X99 - ATX Bench/ Case (PSU Fix)

The PSU wouldn't fit into the mainframe.stl file due to its corners. I fixed this.

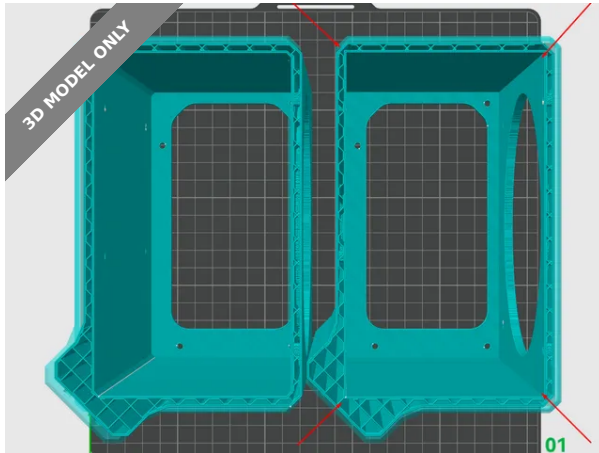
The PSU wouldn't fit into the mainframe.stl file due to its corners.
edit v2 : Also, the PSU power socket didn't fit either, so I fixed that too. I tried it with the 3 PSUs I have and they all fit without any issues, sockets included.
